H.B. KNITEX LTD.

Plot # B26 (P) & B27, Faujdarhat BSCIC Industrial Area, Block-A, Sagorika Road, Custom Academy, South Kattali,
Pahartoli, Chittagong
(22.355954N, 91.773893E)

10 November, 2015

Observations

High Stress at Columns

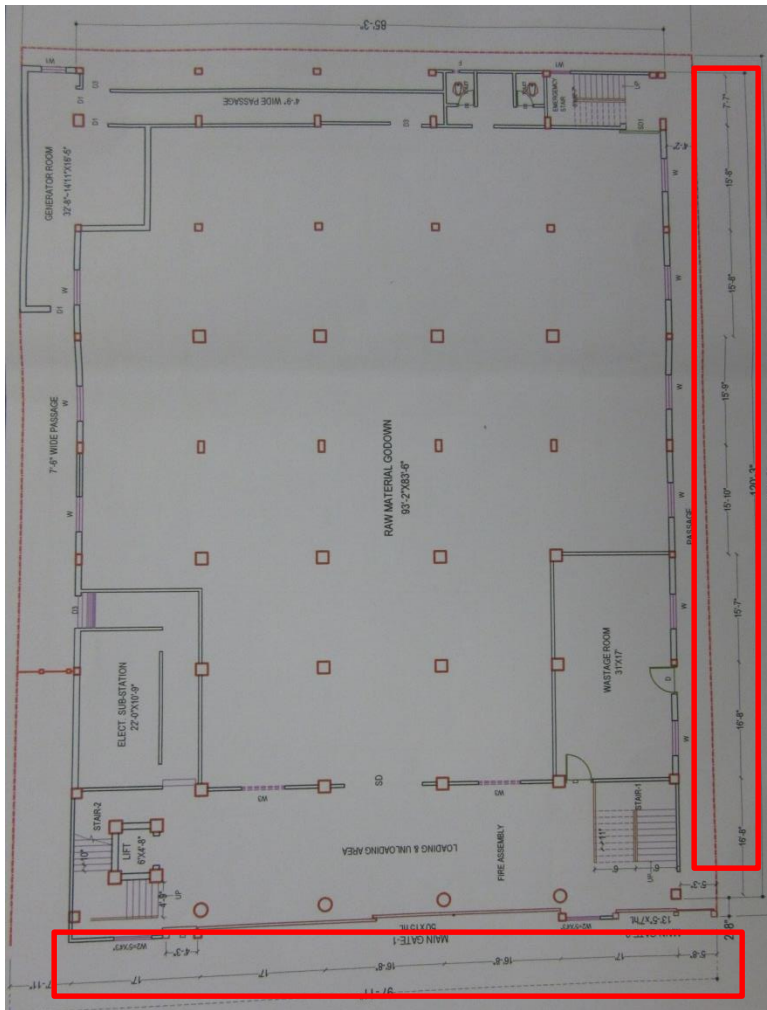
Primary calculation shows the marked columns are highly stressed under gravity loads

4	Highly Stressed Columns	Consideration should be given to strengthening the 250x250 and 300x300 columns.	Immediate - Now

AS built Architectural Drawing

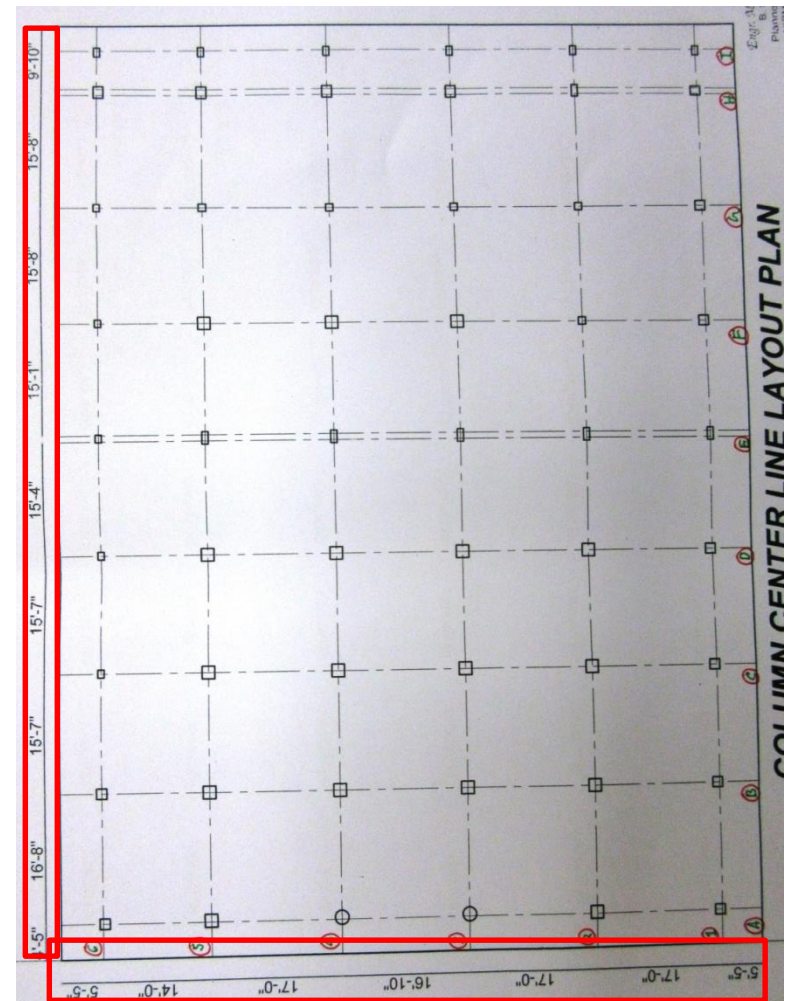
Grid dimensions shown on as-built architectural drawing, do not match with structural drawing. Site observations match with as-built architectural drawing.

Observed dimension and orientation of many columns do not match with structural drawings.

Item No.	Observation	Recommended Action Plan	Recommended Timeline
10	Discrepancies Between Design Drawings and As Built Structure.	As part of the DEA comprehensive As-Built drawings are to be produced.	6-weeks
11	Errors due to Poor Workmanship.	As part of the DEA workmanship errors are to be identified and assessed & appropriate remedial action taken.	6-weeks

Found reinforcement

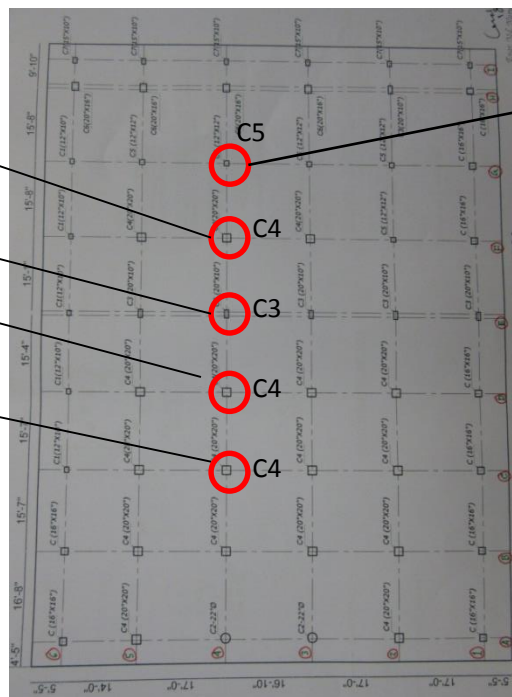
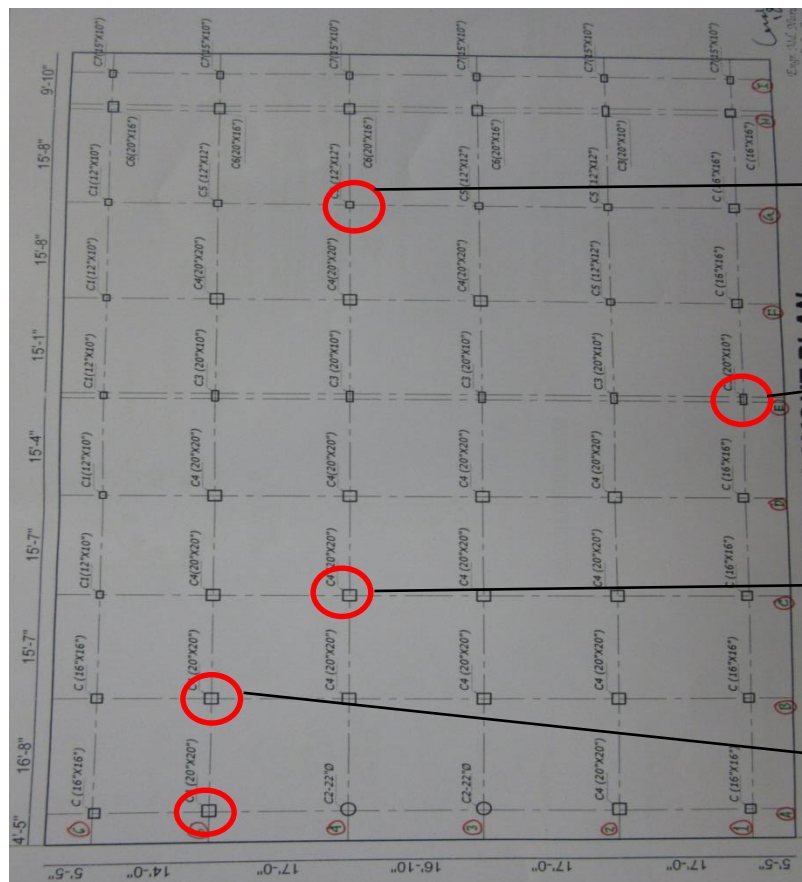
Ferroscope test executed at several columns at ground floor.

The design reinforcement did not match with ferroscreening data

Internal Column
(brick)

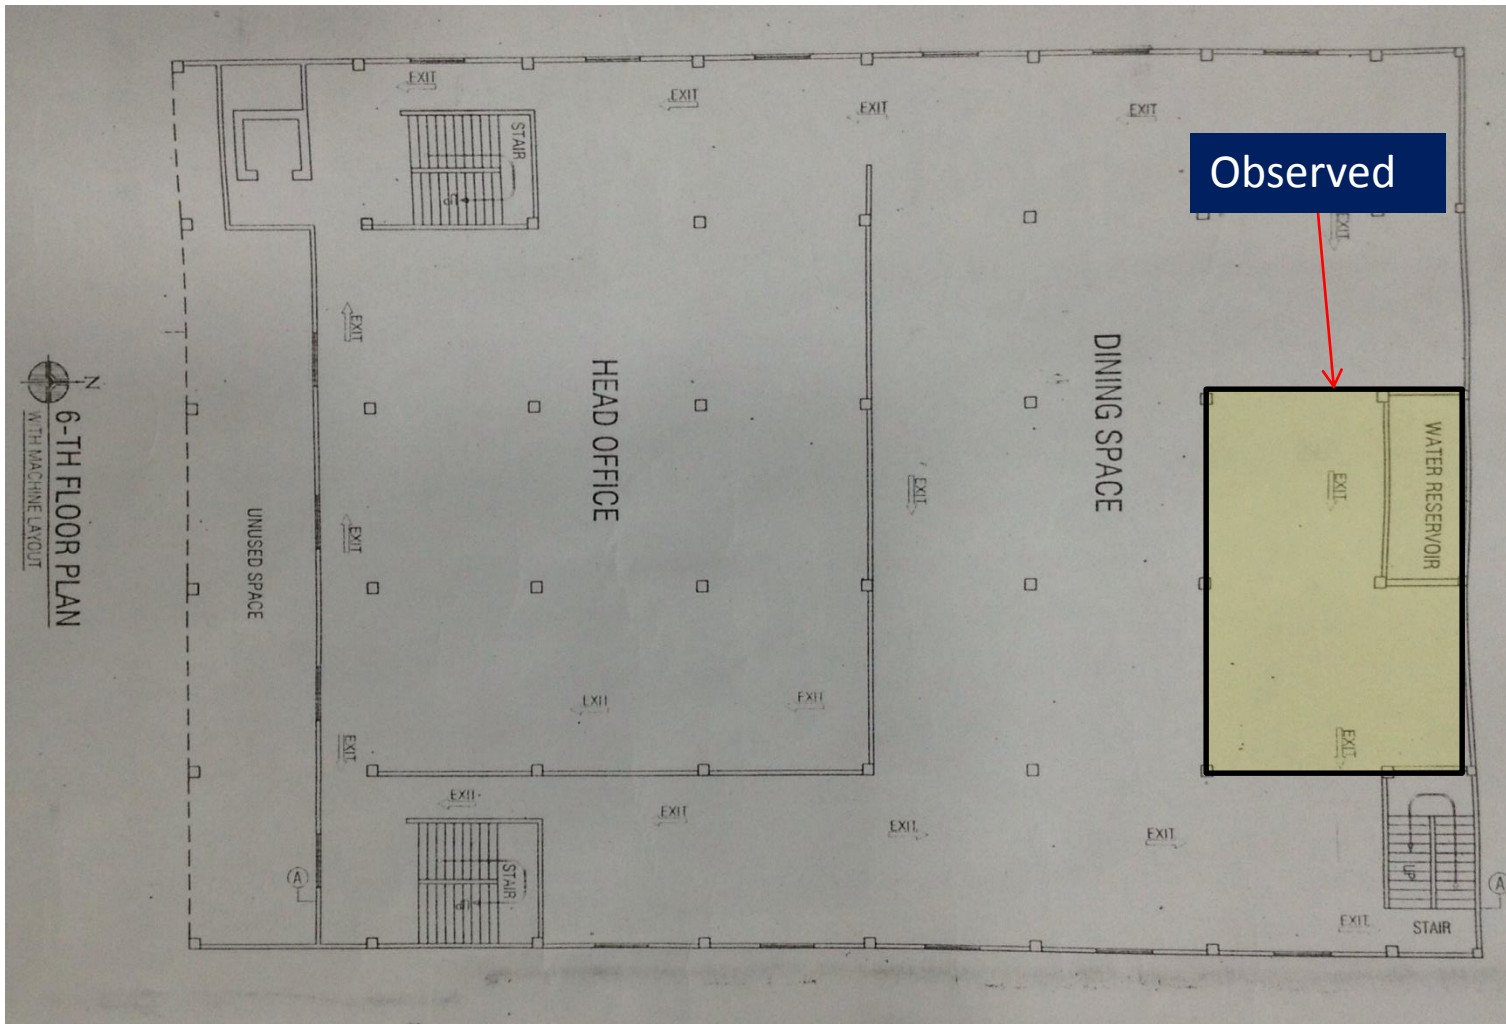
Some ground floor columns had brick aggregate and some had stone. Structural drawings indicated all RC members to be cast with stone aggregates.

Errors due to Poor Workmanship

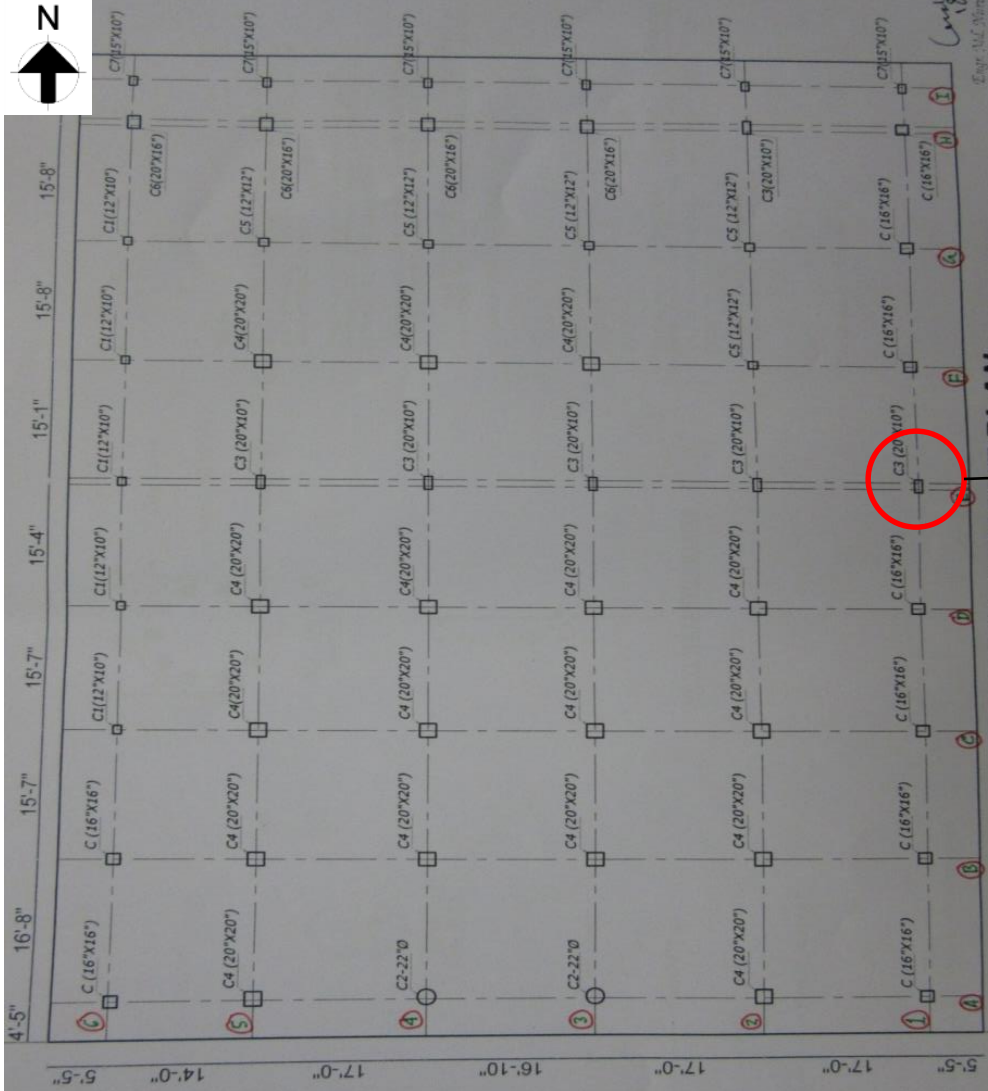
Column was twisted on 5th floor

Gap was found between column and slab

Crack on Edge Column's Plaster

At ground and 1st floors column at grid E1 had plaster crack on outer and inner face. (Crack confirmed not to penetrate into concrete.)
